**ADDENDUM NUMBER: ONE**

**PROJECT: 25A RANGE RENOVATION  
REGINA, SK**

This Addendum forms part of the Contract Documents and amends the original Drawings and Specifications dated 2016-07-21, previous Addenda if applicable and as noted below. This Addendum consists of 5 pages and attached Specification Sections and Drawings as listed below.

DRAWING TITLE  
**COUNTER OPENING DETAIL**

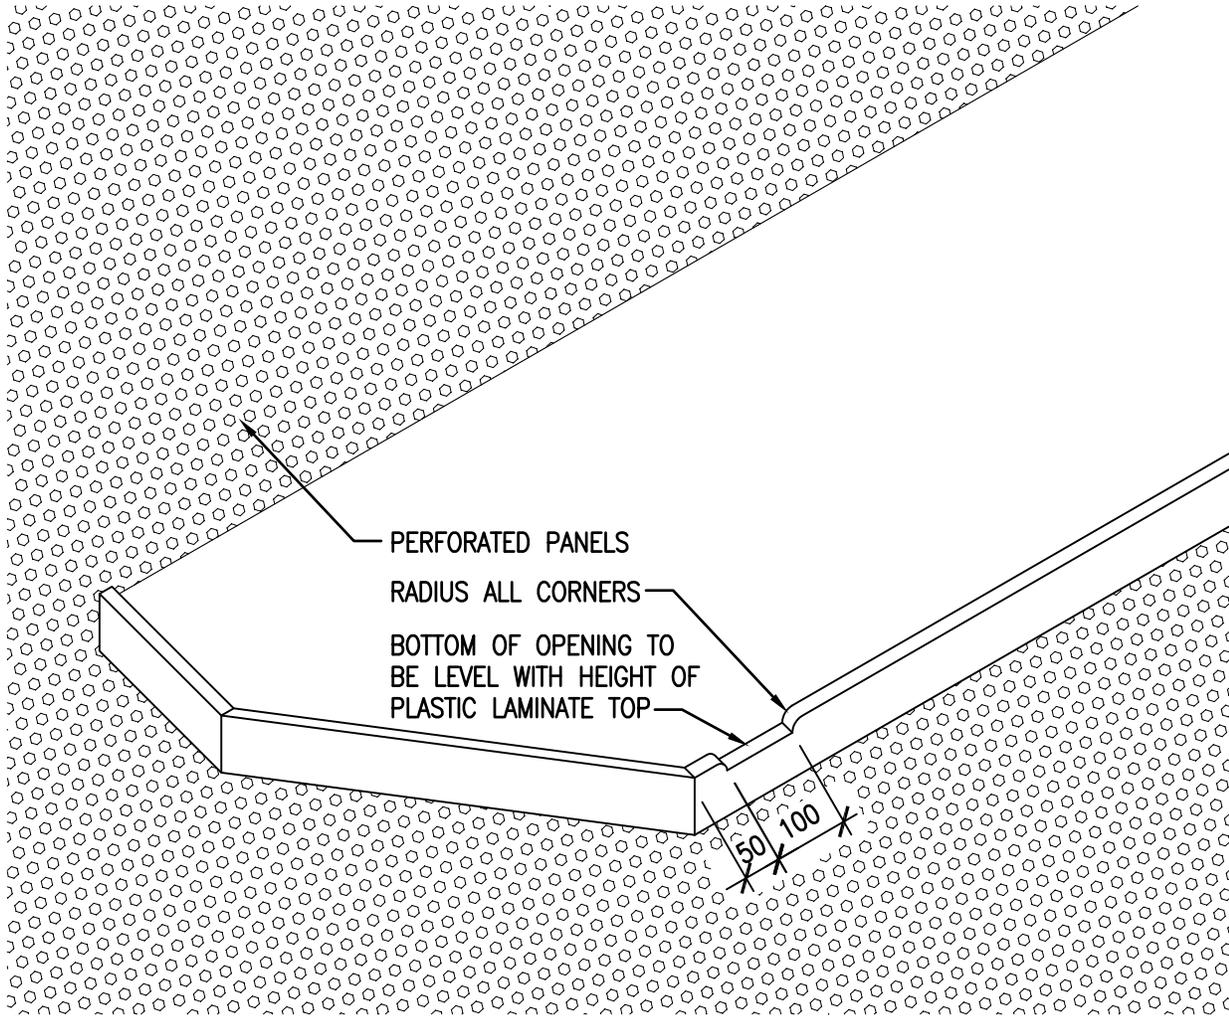
- .1 Reference Drawing 3, South Elevation; PROVIDE a 100mm wide opening in the lip of the wood trim of the counter. Two openings will be required per each section of counter (4 total). Refer to sketch AR01 accompanying this addendum.

2 WALL SECTION  
A2.4 1:20

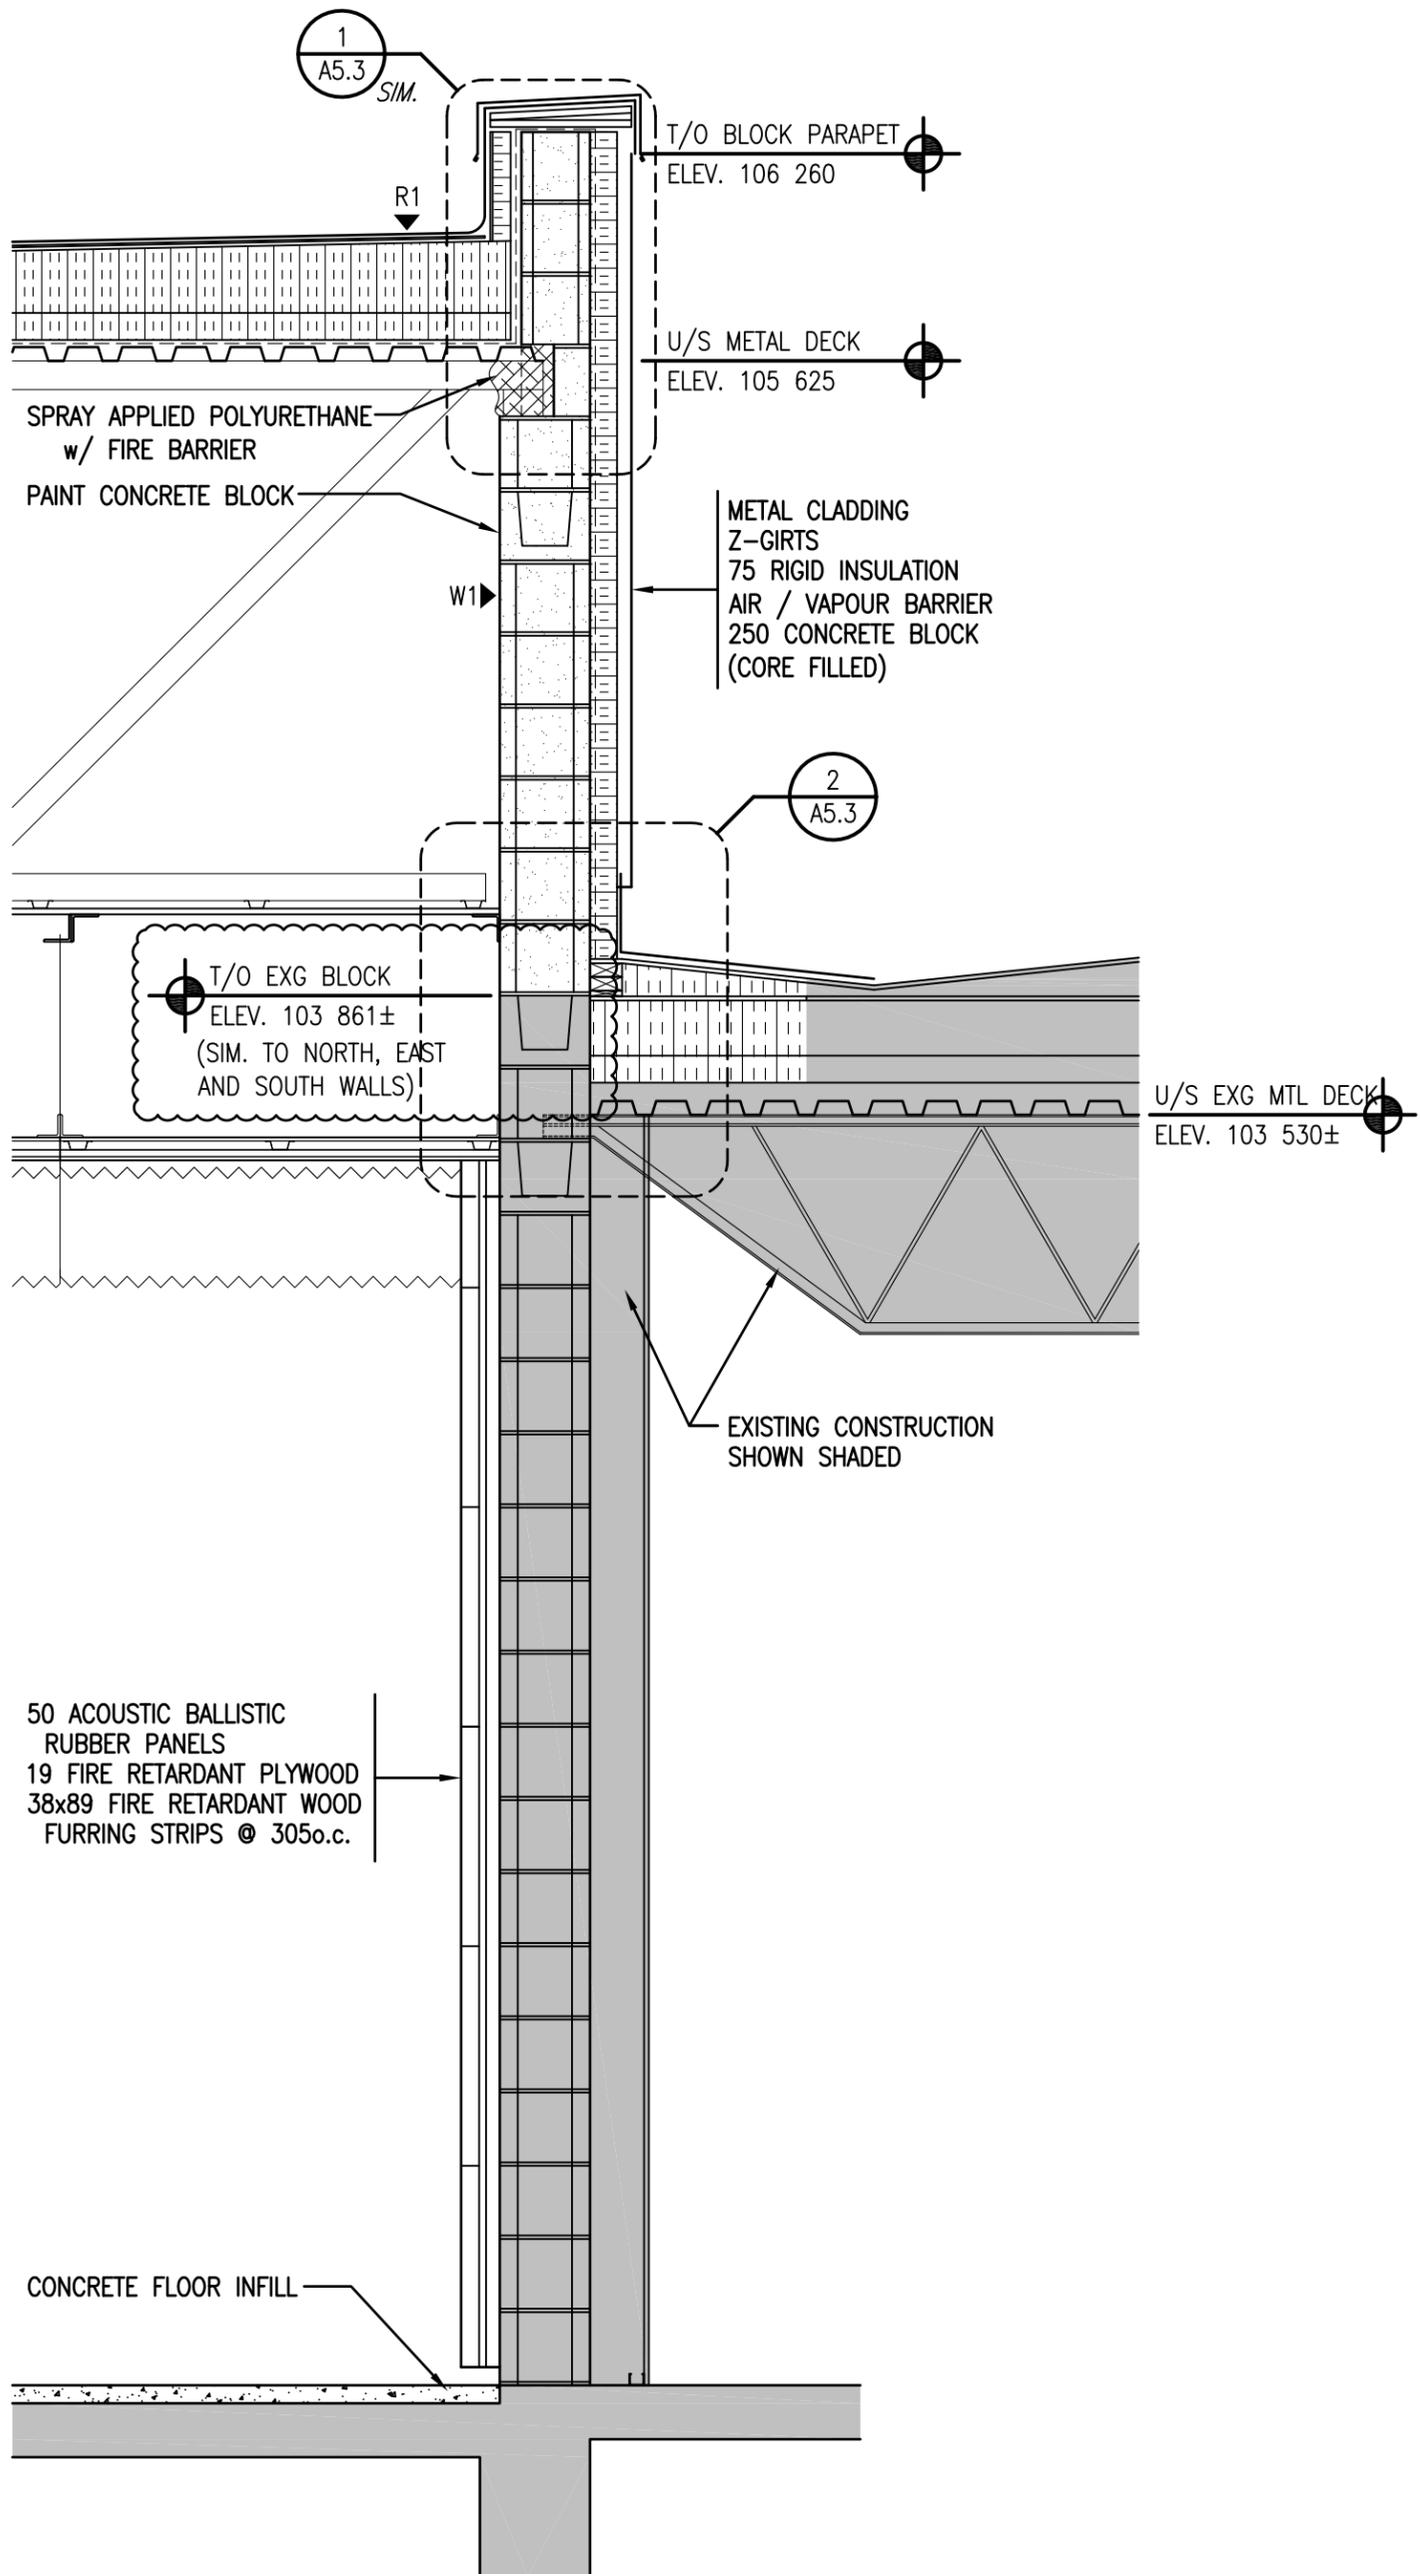
- .1 Reference Drawing 2, Wall Section; REPLACE this detail in its entirety with sketch AR02 accompanying this addendum.
